Arlington Conservation Commission

DEP #091-0356: Notice of Intent: Thorndike Place (Continued from 01/02/2025).

The Conservation Commission will hold a public hearing under the Wetlands Protection Act to consider a Notice of Intent for the construction of Thorndike Place, a multifamily development on Dorothy Road in Arlington. Areas proposed to be altered include Buffer Zone to Bordering Vegetated Wetland and Bordering Land Subject to Flooding associated with Alewife Brook.

January 15, 2025

© 2023 BSC Group, Inc.
SCALE: 1" = 30'
0 15 30 60 FEET
FILE: 2340702\C\2340702-GR
DWG.:
JOB. NO: 23407.02 SHEET C-104

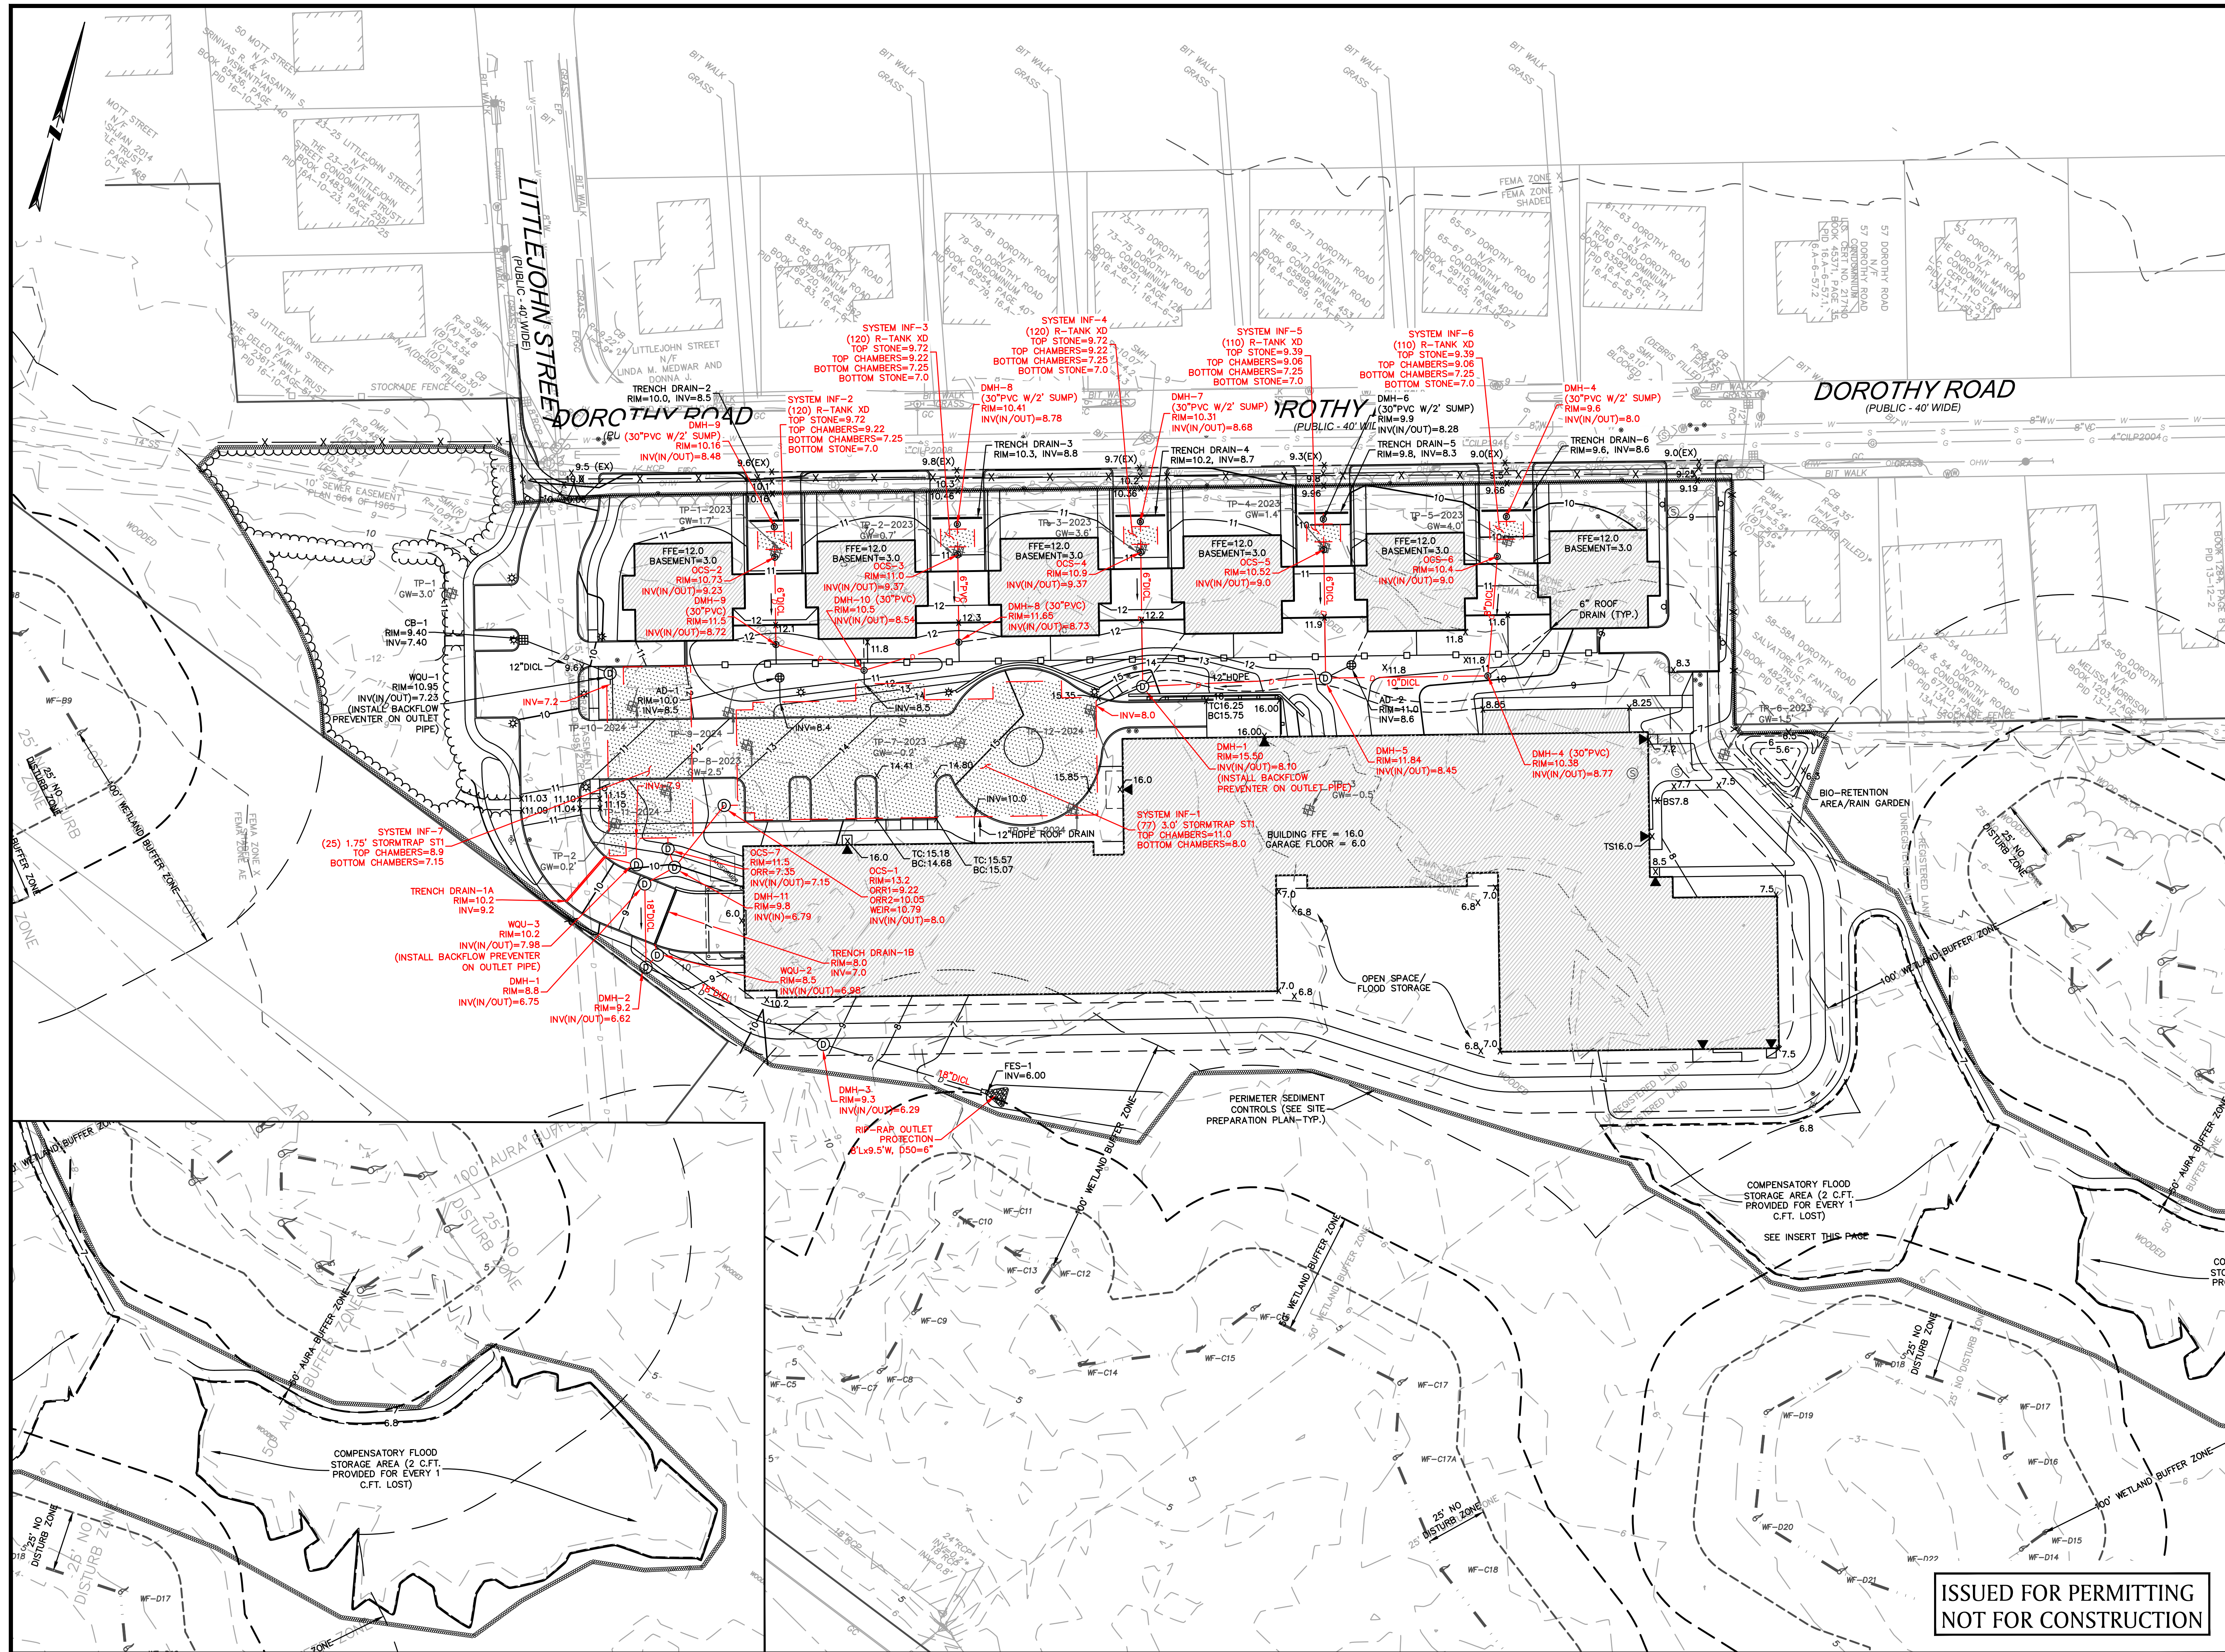
- BSC’s revised design includes raising the bottom of System 1 to elevation (El.) +8-feet, thus creating a claimed vertical separation (i.e., that BSC measures from the chamber bottoms, not the bottom of the proposed stone layer) of exactly 4-feet relative to the proposed ESHGW condition at El. +4-feet. Rather than providing an obvious functional benefit, this modification appears to intentionally target a detail contained in the MSH. Specifically, as noted in Volume 3, Chapter 1 of the MSH, a groundwater mounding analysis requirement is triggered when a proposed system is intended to attenuate peak discharges for certain storm events (i.e., equal to or greater in magnitude than the 10-year, 24-hour event) and less than 4-feet of vertical separation from ESHGW is provided. While BSC is now claiming a groundwater mounding analysis for System 1 can be avoided under the letter of the MSH, the following considerations should be noted:

Sheet C-104 as Infiltration Systems 2-6) consists of varying numbers of R-Tank XD units with the same footprint and a bottom of stone elevation of 7.0 (i.e., 3-feet above estimated seasonal high groundwater), and designed so they maintain a minimum of 10-feet separation from any building foundation. In larger storm events, these systems will overflow to a larger underground infiltration system (Infiltration System 1). A groundwater mounding analysis of these systems has been performed utilizing the total volume infiltrated during the 100-year, 24-hour storm event resulting in an expected groundwater mound of less than 1-foot. A drawdown analysis utilizing the full volume below the lowest outlet and the Rawls Rate for silt loam per GZA's request (0.27 in/hr) has been performed demonstrating that these systems will drain in less than the required 72-hours. The mounding analysis and drawdown calculations are included in Section 6 of the attached Stormwater Report and Summary of Revised Calculations.

- b. A separate underground infiltration system, Infiltration System 7 (see attached Sheet C-104), has been located to the west of Infiltration System 1 and consists of 25 1.75-foot StormTrap chambers with a bottom elevation of 7.15 (which corresponds to 3.15-feet above ESHGW). This system collects runoff from driveway and paved areas associated with the multi-unit building. A groundwater mounding analysis of this system has been performed utilizing the total volume infiltrated during the 100-year, 24-hour storm event resulting in an expected groundwater mound of less than 3 feet. A drawdown analysis utilizing the full volume below the lowest outlet and the Rawls Rate for silt loam has been performed demonstrating that this system will drain in less than the required 72-hours (see Section 6 of the attached Stormwater Report and Summary of Revised Calculations). As part of this design, an additional trench drain has been added to the driveway entrance to the multi-unit building to collect runoff and route it into Infiltration System 7 after passing through a water quality unit.

- c. During larger storm events, both Infiltration Systems 1 and 7 overflow to a flared end section (FES-1) to the south of the multi-family building via outlet control structures that connect to a new drain manhole. This is the same discharge point as in the previous designs (see attached Sheet C-104). Please note that the two systems are not connected to each other, but overflow to the same point.

has been eliminated as well, and all roof runoff from this building is routed via roof drains to Infiltration System 1 (see attached Sheet C-104).

FILE: \Civil\Drawings\2340700-LM
JOB. NO: 23407.02 SHEET L-100

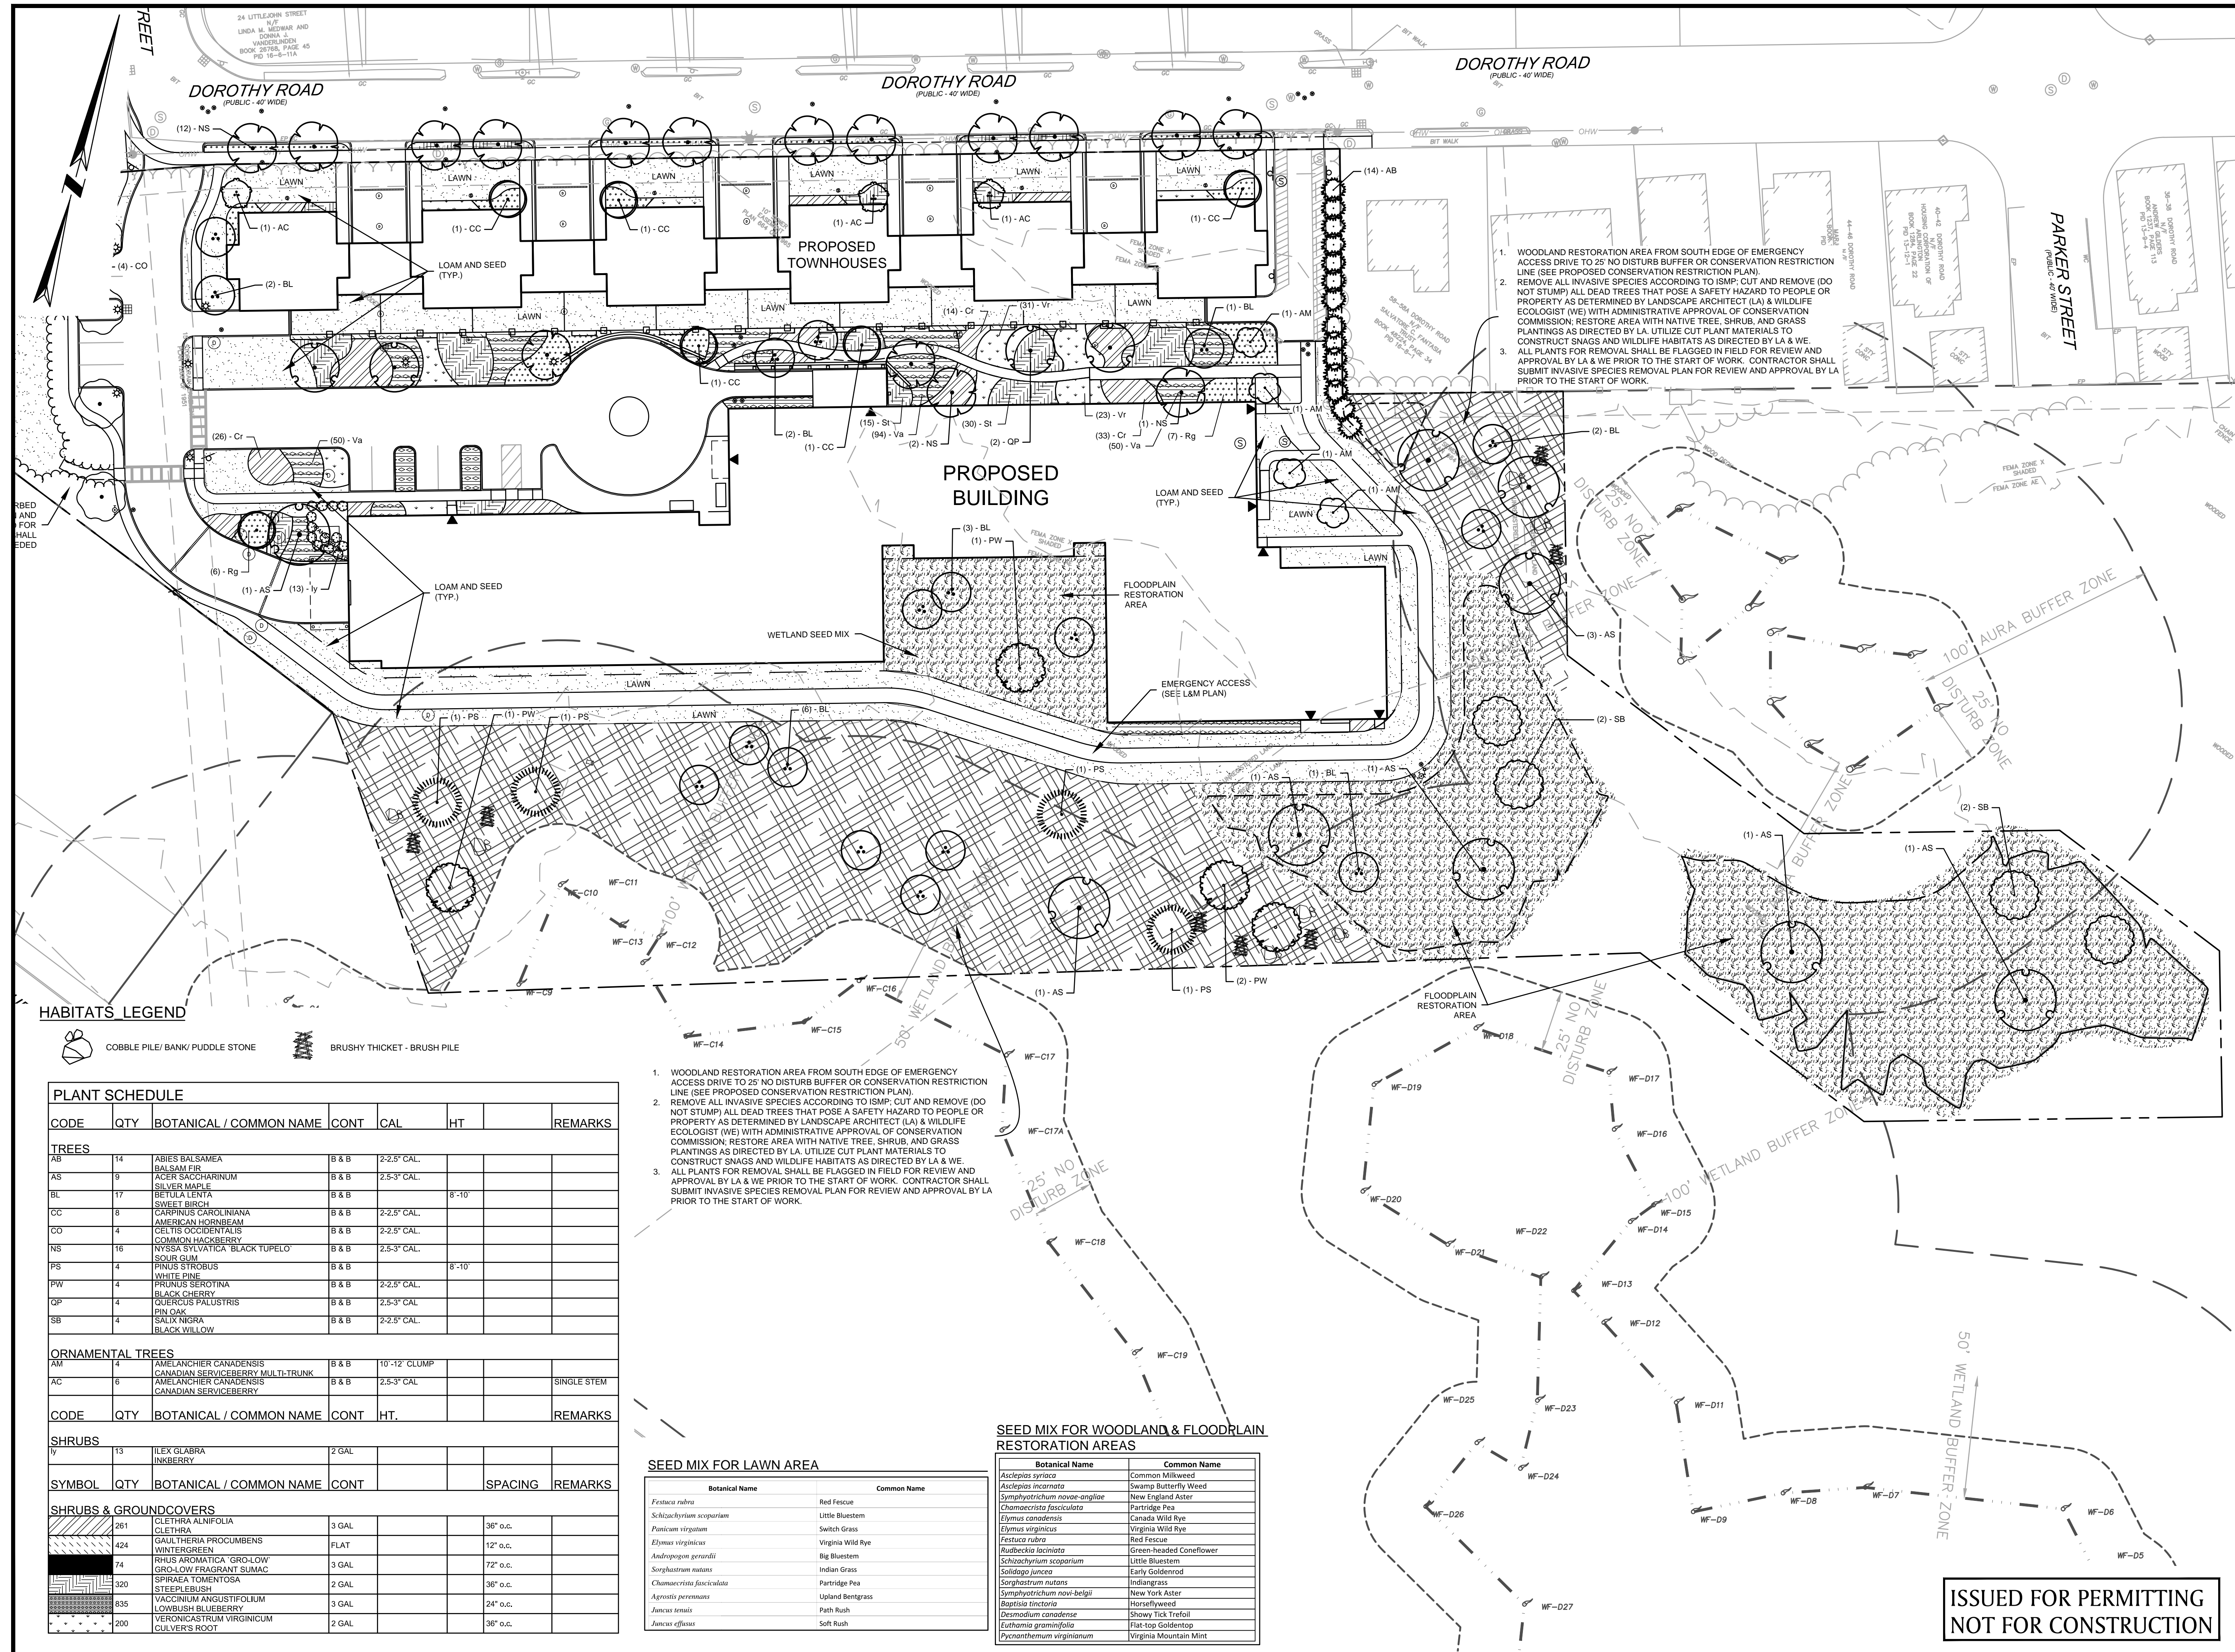
SWCA Comment 9: Sheet L-100, Plant Schedule. The plant schedule includes a number of proposed cultivars within the 100-foot Buffer Zone (e.g., *Clethra alnifolia* 'ruby spice', *Hydrangea quercifolia* 'ruby slippers', and *Hydrangea arborescens* 'annabelle'). In accordance with condition I.24 of the Comprehensive Permit, all mitigation plantings and plantings within all resource areas shall be native, non-cultivar species. Additionally, other cultivars are proposed in other areas of the site along side non cultivars of native species (e.g., pin oak [*Quercus palustris*] and green pillar pin oak [*Q. palustris* 'pringreen']).

SWCA Comment 10: Sheet L-100. A note on the plans indicates that all dead trees (i.e., snags) that do not provide wildlife habitat per the landscape architect and wildlife ecologist should be removed. Snags provide a wide variety of valuable habitat functions for wildlife including forage for insects, perches to hunt from, shelter if there are cavities or cracks, and other functions.

BSC Response 5-1: Please refer to Sheet L-100. No tree is proposed within the restoration area or compensatory flood storage area that is not specifically listed in SWCA Comment 5. BSC is providing a color-markup of the restoration planting sheet to clarify proposed species placements.

BSC Response 10: BSC concurs with SWCA Comment 10 and has revised Sheet L-100 according to SWCA's Comments 1 and 10.

BSC Response 10-1: The note on Sheets L-100 has been updated to state, "2. Remove all invasive species according to ISMP; cut and remove (do not stump) all dead trees that pose a safety hazard to people or property as determined by Landscape Architect (LA) & Wildlife Ecologist (WE) with administrative approval of Conservation Commission; restore areas with native tree, shrub, and grass plantings as directed by LA. Utilize cut plant materials to construct snags and wildlife habitats as directed by LA & WE.
